City of Ryde Local Planning Panel Meeting No. 4/20

- 1 96 WEST PARADE, DENISTONE. CONSTRUCTION OF A TWO STOREY BOARDING HOUSE COMPRISING 8 X 2 BED BOARDING ROOMS AND A DOUBLE GARAGE. THE PROPOSAL PROVIDES 4 CAR PARKING SPACES, 2 MOTOR CYCLE PARKING SPACES AND 4 BICYCLE PARKING SPACES - LDA2019/0445**

City of Ryde Local Planning Panel Report

DA Number	LDA2019/0445
Site Address & Ward	96 West Parade, Denistone NSW 2114 Lot 2 in Deposited Plan 345520 West Ward
Zoning	R2 Low Density Residential
Proposal	Construction of a two storey child care centre for 96 children and 16 staff with basement parking for 18 vehicles. Proposed hours of operation are 7:00am to 6:00pm Monday to Friday.
Property Owners	Anthony Ceretto
Applicant	Designcorp Architects
Report Author	Brendon Clendenning Consultant Planner
Lodgement Date	13 December 2019
Notification - No. of Submissions	Seventeen (17) submissions received, all objecting to the proposed development.
Cost of Works	\$2,000,465.56
Reason for Referral to LPP	Contentious development – (b) in any other case – is the subject of 10 or more unique submissions by way of objection. <i>Schedule 1, Part 2 of Local Planning Panels Direction</i> <i>and</i>

Figure 10: Extract of proposed ground floor plan.
Source: Designcorp Architects, dated: 05/09/2019

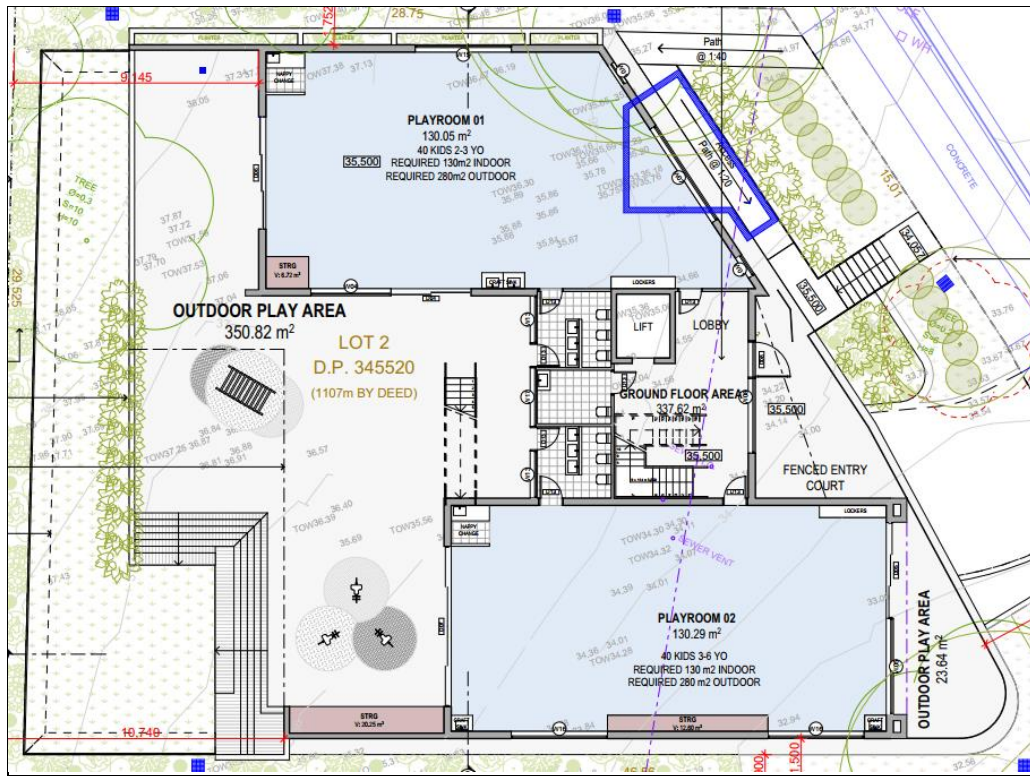
- The area in question is not open for more than a third of the perimeter
- The perimeters are surrounded by walls more than 1.4m high (noting the large wall at the rear of the play area, which at its lowest point is approximately 1.5m high).
- The majority of the area is roofed.

Figure 32: Extract of submitted section plan showing sunken outdoor play area.
Source: Designcorp Architects, dated: 05/09/2019

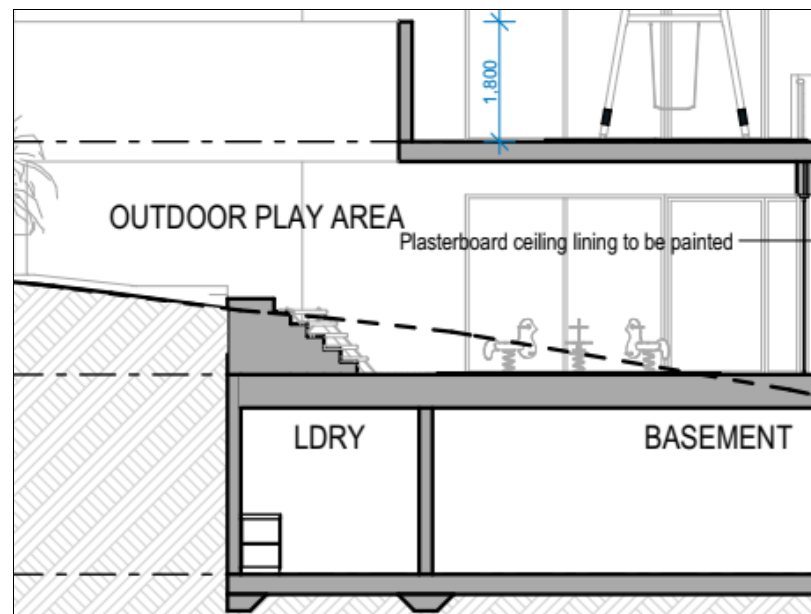
As well as being sunken below ground level, this area is almost entirely covered by the level above, with the only open area provided with a southern orientation. This element of the proposal provides exceptionally poor amenity.

Figure 13: Estimate of area of basement level that does not meet the basement definition.

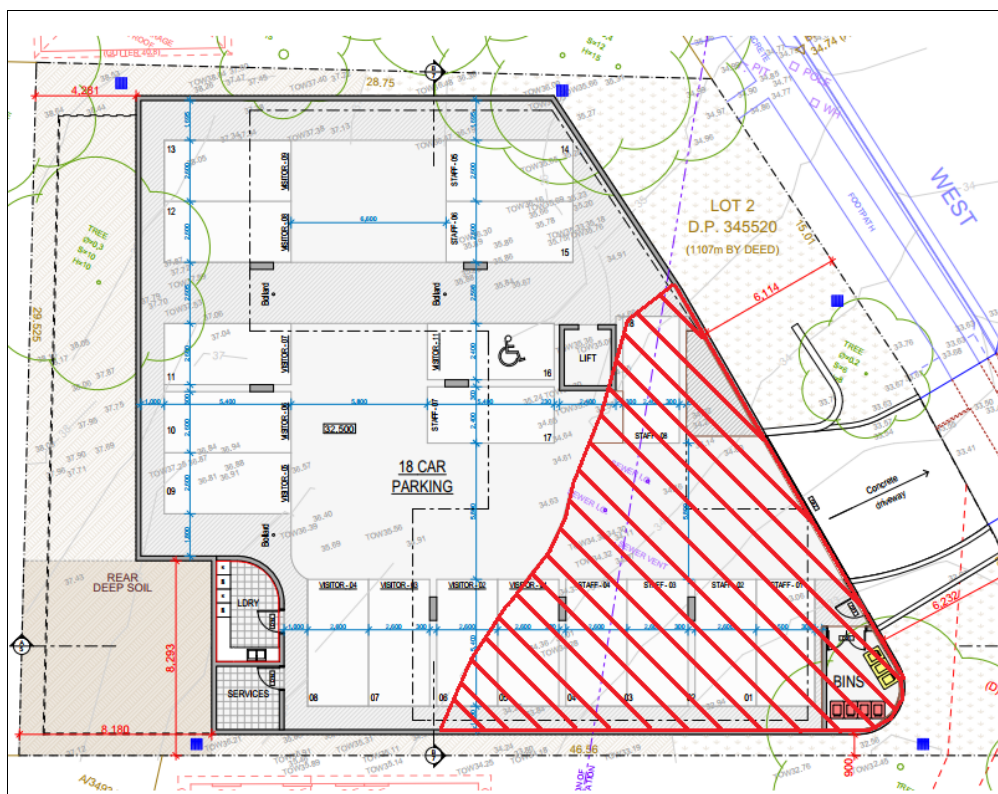
In addition, the definition of ‘basement’ contained within RLEP 2014, excludes those areas where the floor level of the storey immediately above is greater than 1m above ground level (existing). On this basis, the south-eastern component of the basement garage (approximately one third of the total basement area) does not meet the definition of ‘basement’. Refer to image below which provides an estimate of the area excluded from the definition.

Otherwise, areas of the basement that would contribute to the GFA calculation, include the bin storage, surplus circulation space in the south-eastern corner, and the laundry (located further to the west). The total FSR figure is therefore likely to be even higher than 0.895:1.
